Downtown West

Design Standards
and Guidelines
Errata

May 07, 2021

ERRATA

FIGURE 1.8: DWDSG framework plan

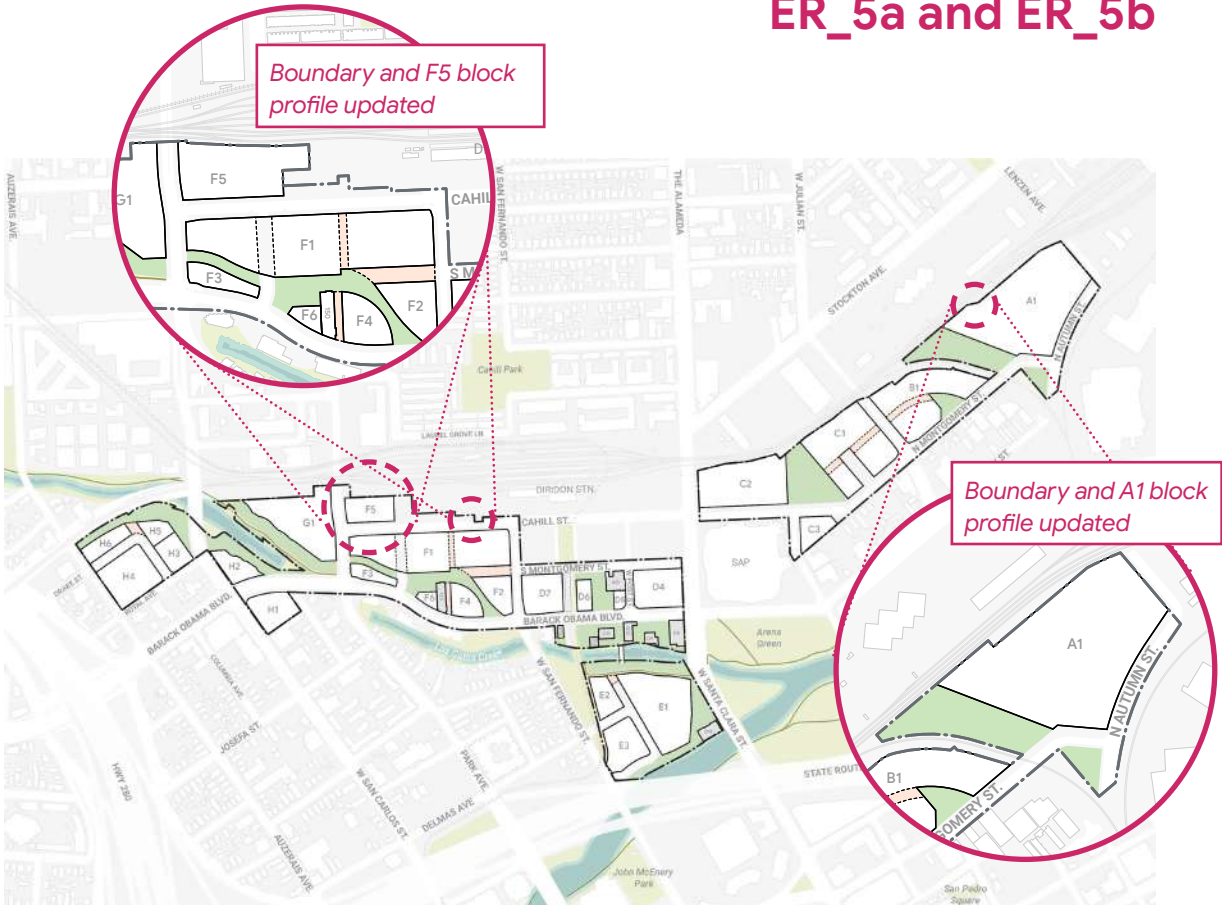
ER_5a	21	Document Overview	Figure 1.8	Site boundary and block profile changes at F5 and A1
ER_5b	21	Document Overview	N/A	The standards and guidelines in the DWDSG permit a limited range of land uses, massing, and circulation options, which may result in a block plan that differs from the DWDSG framework plan. Refer to the Vesting Tentative Map and subsequent Final Maps for dimensioned lot boundaries.
ER_6	30	Project Vision	Figure 2.2	Site boundary and block profile changes at F5 and A1
ER_7	49	Land Use	Figure 3.2	Site boundary and block profile changes at F5 and A1
ER_8	52	Land Use	Figure 3.3	Site boundary and block profile changes at F5 and A1 and southern infrastructure zone boundary extension
ER_9	56	Land Use	Figure 3.6	Site boundary changes and removal of non-building elements identified for demolition
ER_10a	71	Open Space	S4.5.2	“A minimum of 4.80 acres of the approximately 15 total acres of Project open space shall be City-dedicated open space, and shall, at minimum, meet the total acreages shown for Los Gatos Creek Multi-Use Trail and City-dedicated parks identified in Table 4.1: ”

FIGURE 3.6: Demolition and retention plan

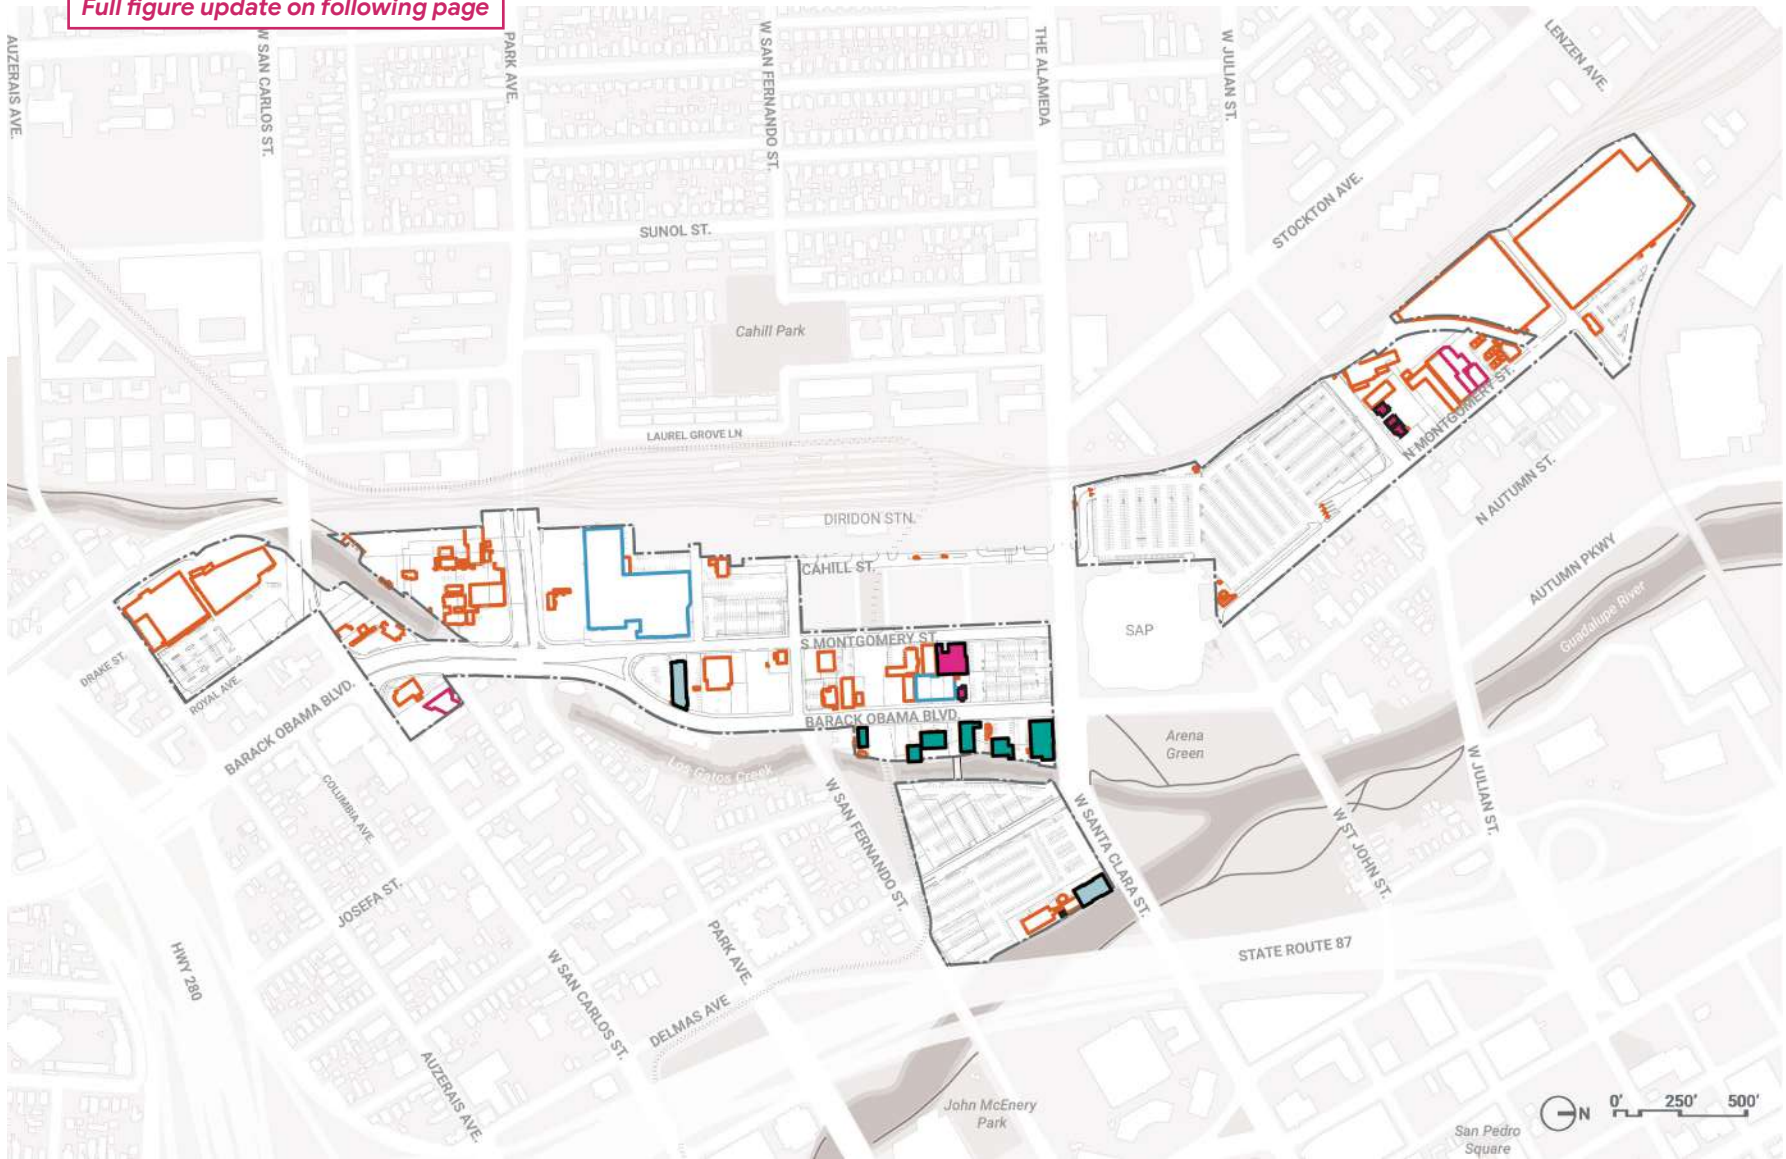
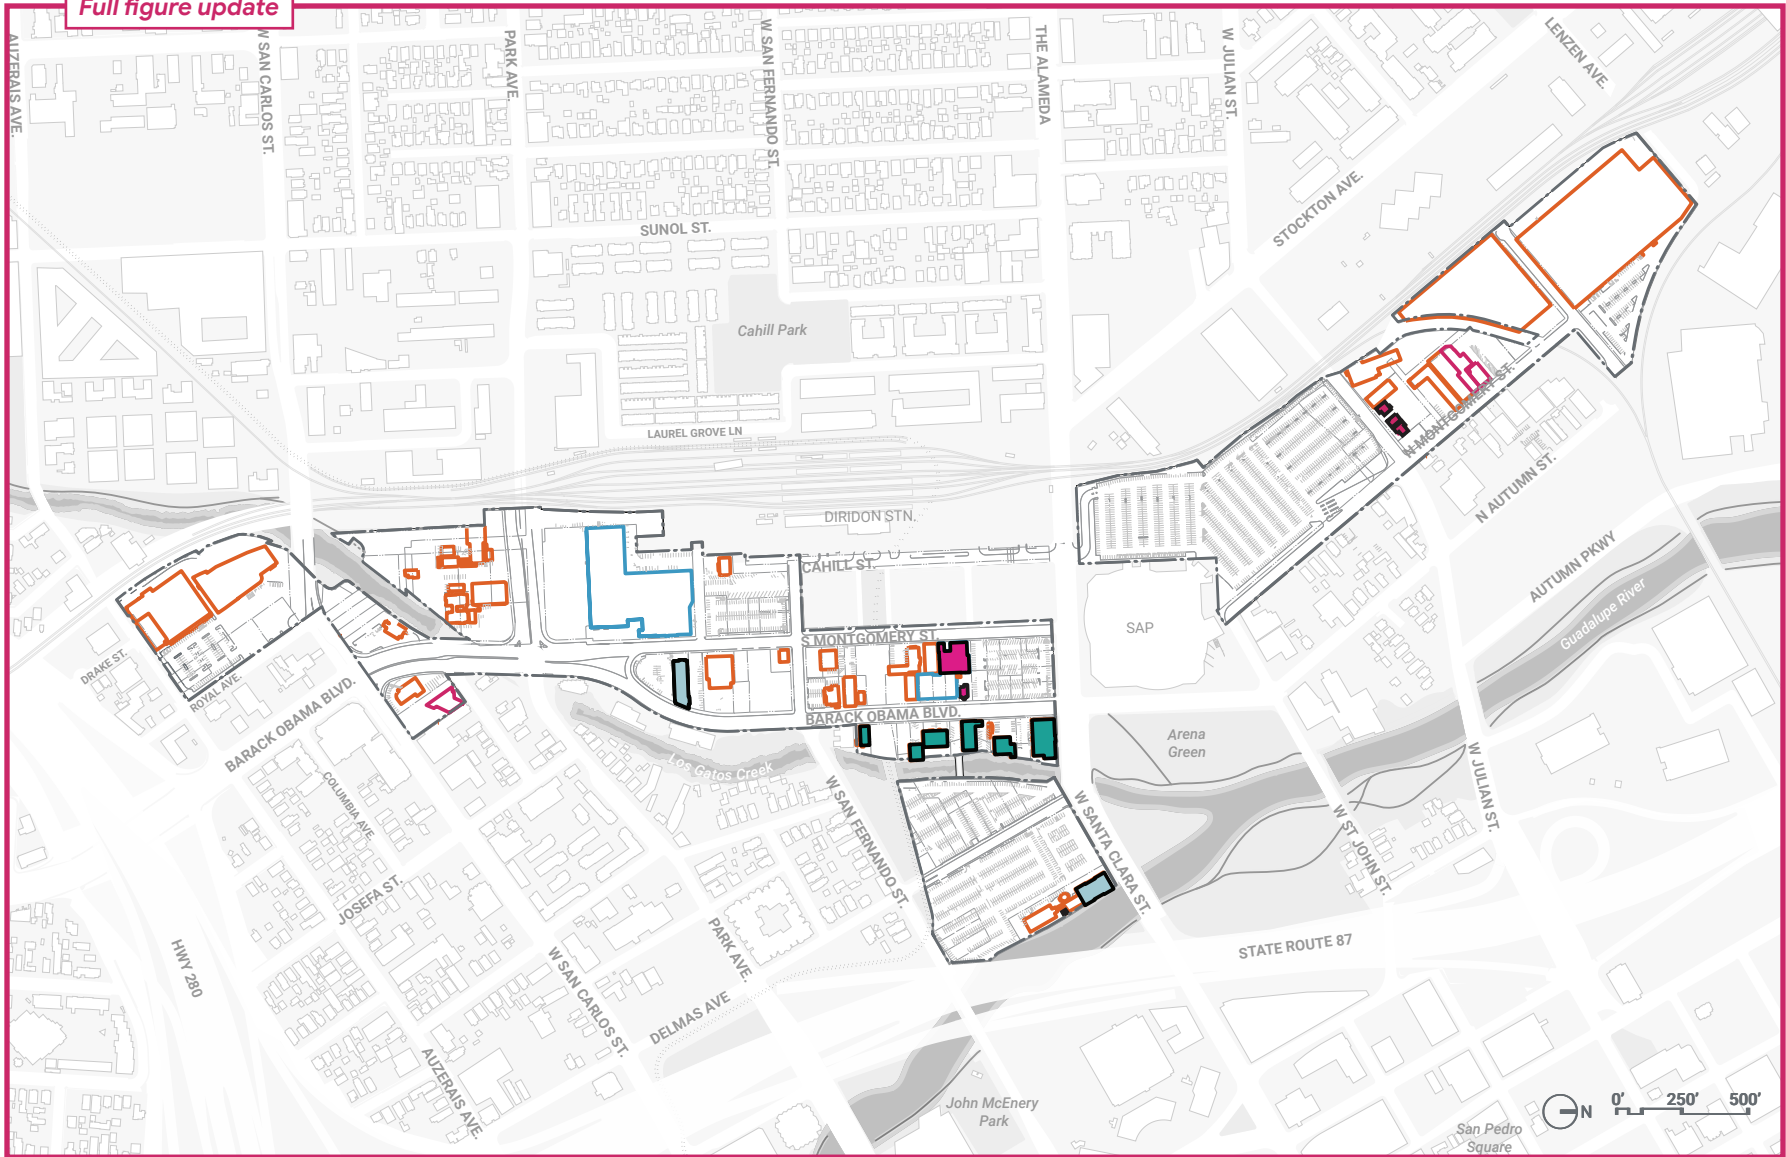
Full figure update on following page

Full figure update

FIGURE 4.49: Illustrative plan of Gateway to San José

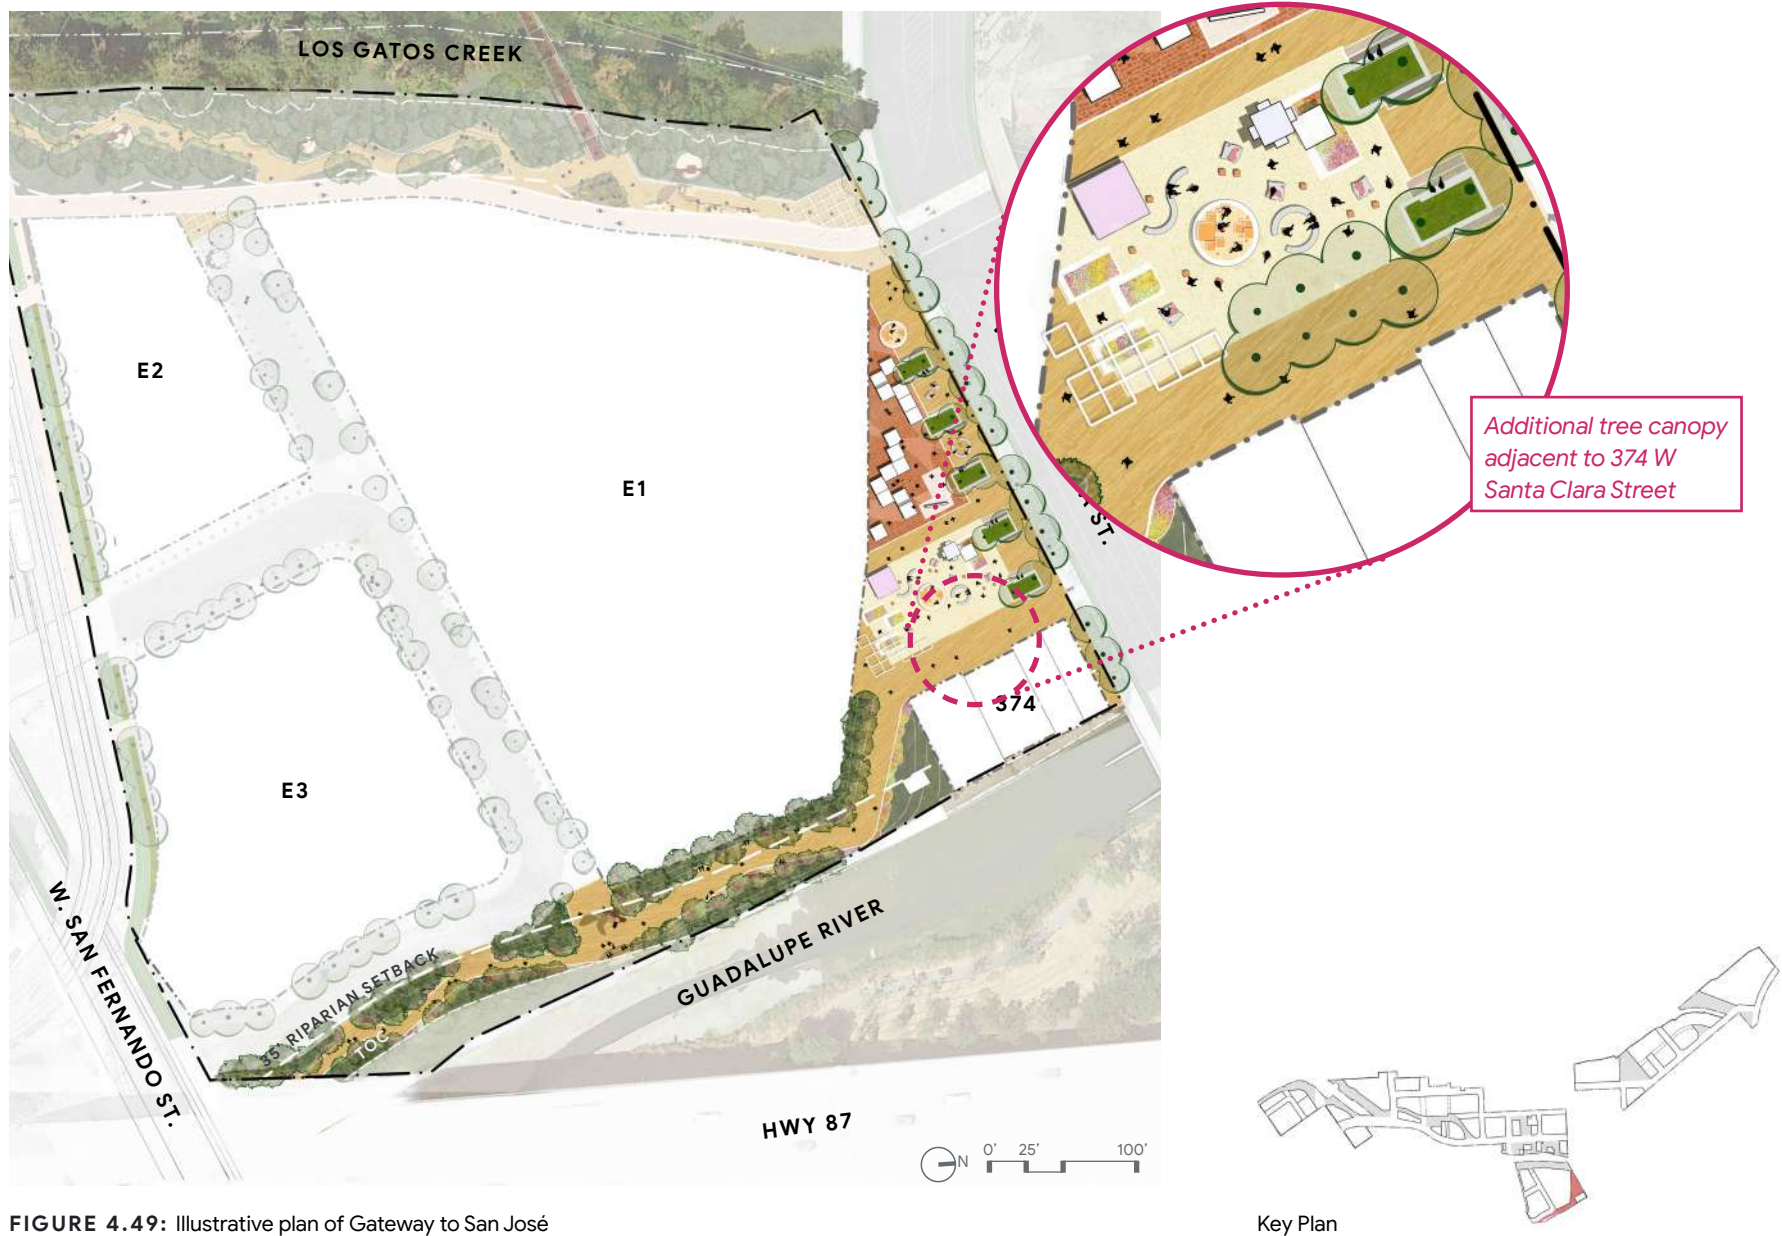
ERRATA ID	DWDSG PAGE NUMBER	DWDSG CHAPTER	DWDSG CONTENT	DESCRIPTION OF UPDATES
ER_10c	134	Open Space	Figure 4.49	Additional tree canopy adjacent to 374 W Santa Clara Street
ER_10d	136	Open Space	Figure 4.50	Additional tree canopy adjacent to 374 W Santa Clara Street
ER_10e	148	Open Space	Figure 4.60	Additional tree canopy adjacent to 374 W Santa Clara Street
ER_11	150	Open Space	Table 4.15	Addition of “California Hazelnut, <i>Corylus cornuta</i> Marsh. var. <i>californica</i> ” to plant species list
ER_12	156	Open Space	S4.25.4	“Serviced and unserviced pavilion structure that use glazing as a material shall provide glazing units with visible light transmittance below 60 percent which shall not count toward the required transparent area. Existing structures that are relocated as pavilions shall be exempt from transparency requirements. ”
ER_13	156	Open Space	S4.25.6	“Public restrooms, park maintenance and storage facilities, and park management offices shall be permitted supportive structures for open spaces active uses; see Section 3.1 . No single park maintenance structure shall exceed 1,500 square feet in interior area. Park maintenance structures shall not exceed 20 feet in height above finished grade as measured to top of roof. Park maintenance structures are permitted in either the open space or the interior of an adjacent building, new development blocks, or other space outside of street right-of-way . If provided as a standalone structure in the open space, the structure size cannot exceed the maximum cover limit described in Table 4.16.”

FIGURE 4.50: Required (R) and complementary (C) Gateway to San José programmatic elements diagram

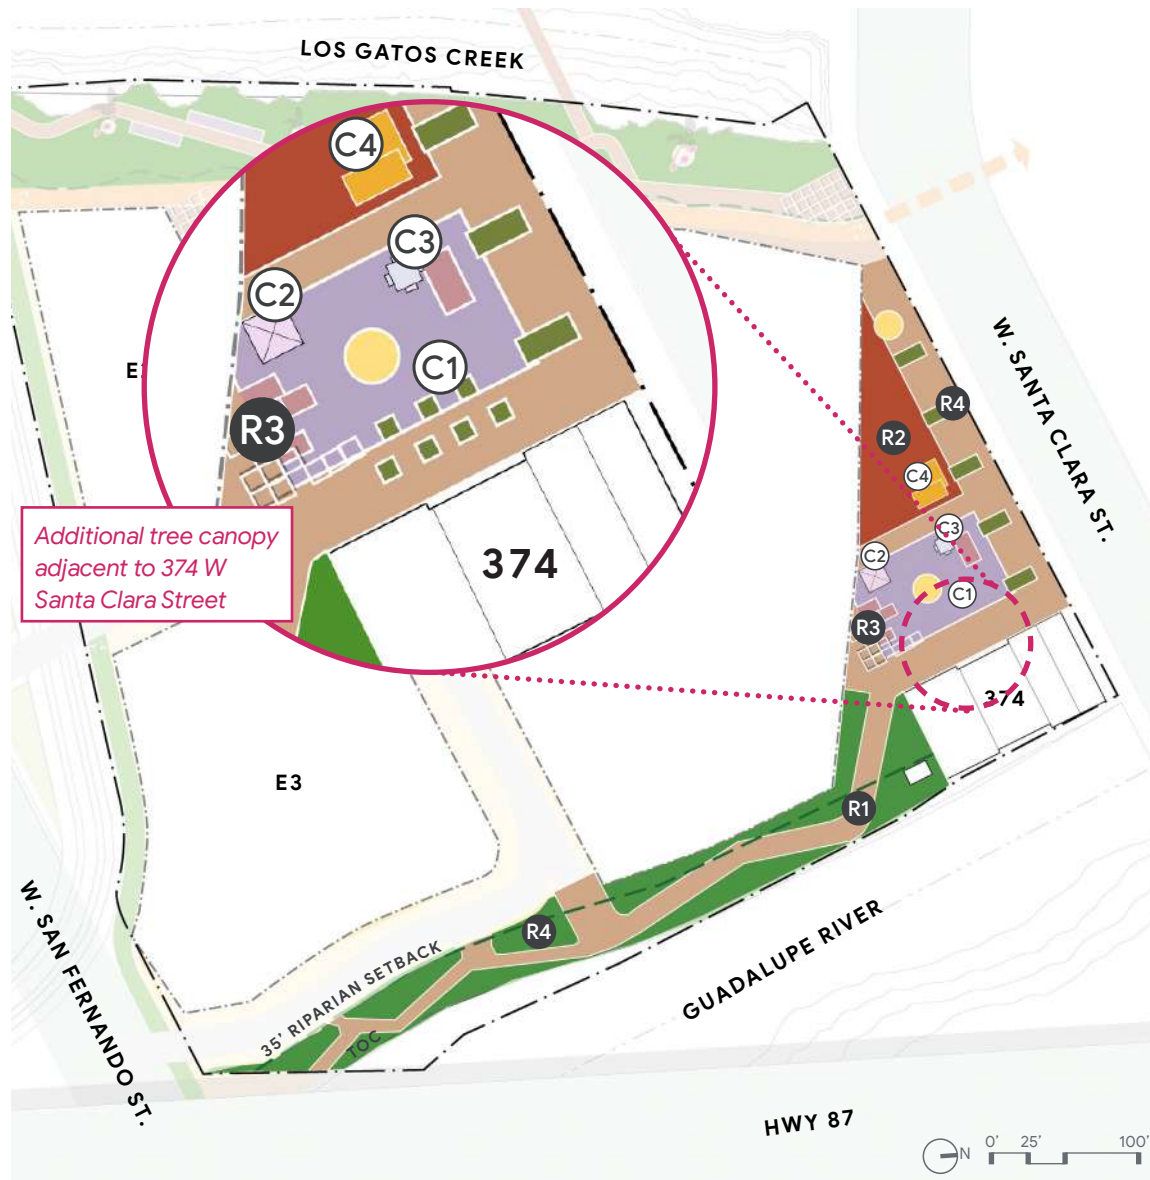
Additional tree canopy adjacent to 374 W Santa Clara Street
